Hazelwood Rehabilitation Investigation Report

Ref: RPT012

Minister for Resources, Jaala Pulford MP, referred to the Mine Land Rehabilitation Authority (the Authority) on 30 September 2021 five matters for investigation related to rehabilitation planning for Hazelwood mine (Mining Licence Number 5004) in the Latrobe Valley, Victoria. The five matters, published in Government Gazette G.39 comprise:

Figure 2.6 PoF for the 7^o and the 9^o water gradients at RL+8 and RL+25 (Reproduced from Figure 35, GHD (2018))

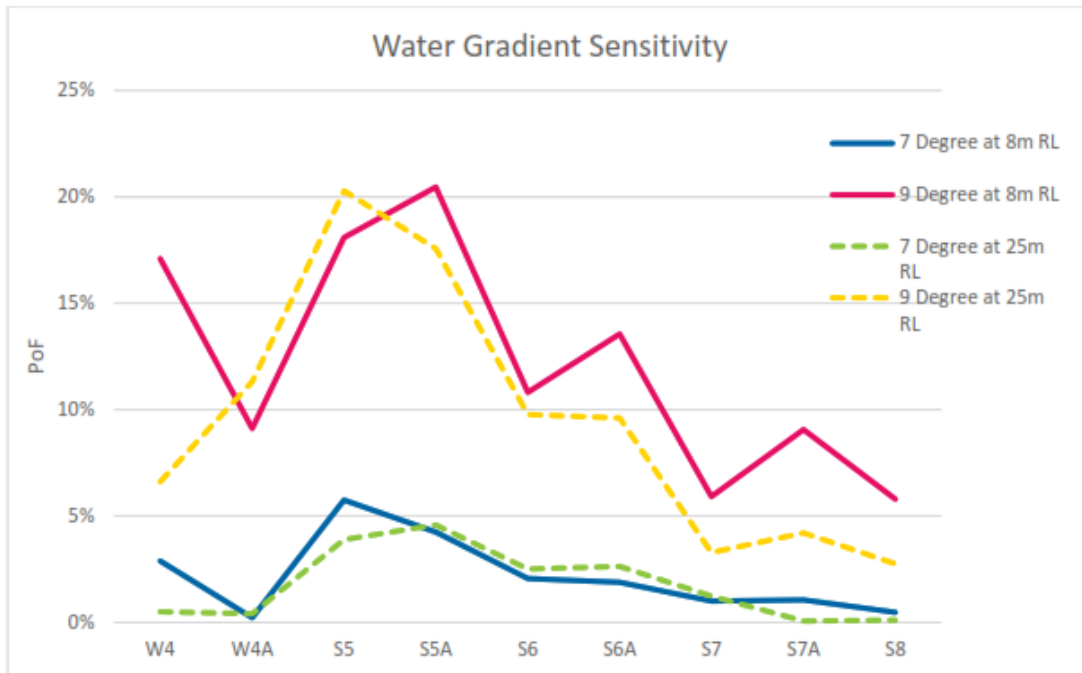
The second aspect concerns the stress relief that could occur in the ground behind the failure zone. Horizontal and vertical ground movements will be reactivated that could potentially impact sensitive receptors behind the batter. An example would be horizontal strains across the Princes Freeway and the Morwell Main Drain leading to defects in both structures. While the expectation is that the batter designs will minimise the risks of failure, measures of consequence need to be included in such a way that they focus attention on possible long-term impacts and on those areas of the mine where the consequences of a failure are greatest. Consideration of displacement volumes alone does not meet this objective.

Sensitivity studies are appropriate where features of the stability analysis are not amenable to inclusion in the basic probabilistic risk analysis. Hazelwood sensitivity studies have targeted temporal changes to the driving forces influencing batter stability. These include lake levels, groundwater gradients, over-pressures in coal joints, and uncontrolled inflows to groundwater from permanent surface water bodies, and seismic events. Additional studies have explored the local stability of emplaced rock masses.

Discrete simulations of batter stability at representative lake water levels are appropriate. From these it should be possible to interpret the likely failure risks at intermediate levels. The ability to do this depends to a significant degree on the complexity of the batter geometry. In practice, a demonstration of the stability of the batter at potentially critical levels, other than the representative levels, should be undertaken to provide assurance that the water levels corresponding to the maximum risk for each batter are identified. Critical levels will likely correspond to water heights identified by marked changes in batter geometry at the water line.

Figure 2.8 Comparison of PoF results during lake filling for the East Field Northern Batters (EFNB) and the West Field Southern Batters (WFSB) showing the design acceptance criteria (shaded area)

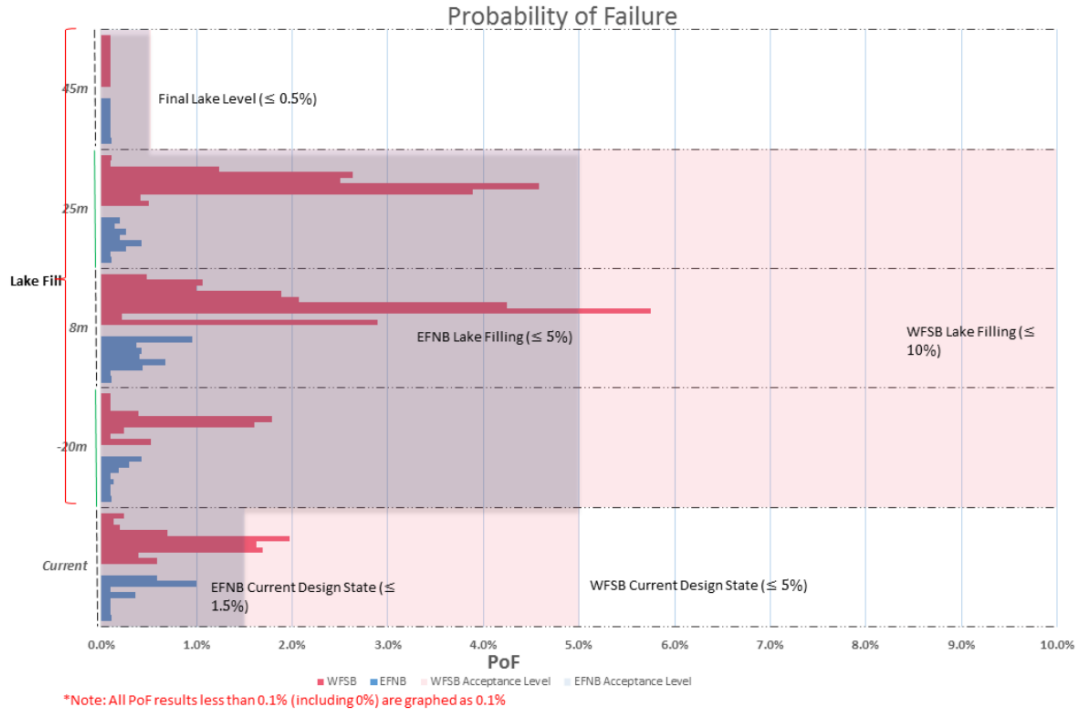
Figure 2.8 illustrates ENGIE’s design acceptance criteria for the East Field Northern Batters and the West Field Southern Batters. Also shown are the assessed PoFs for the base cases for each batter for each representative lake water level.

Design PoF should be based on slope design life, ground controls, and failure consequence. The design acceptance levels presented in Table 6 cover each of these criteria. Design life addresses serviceability. Ground controls are based around monitoring but not actions. Failure consequences are based around public risks but not about risks to the environment or infrastructure. While this table is good as a starting point for establishing design acceptance levels for PoF, additional evidence is required to build confidence in the adopted values.
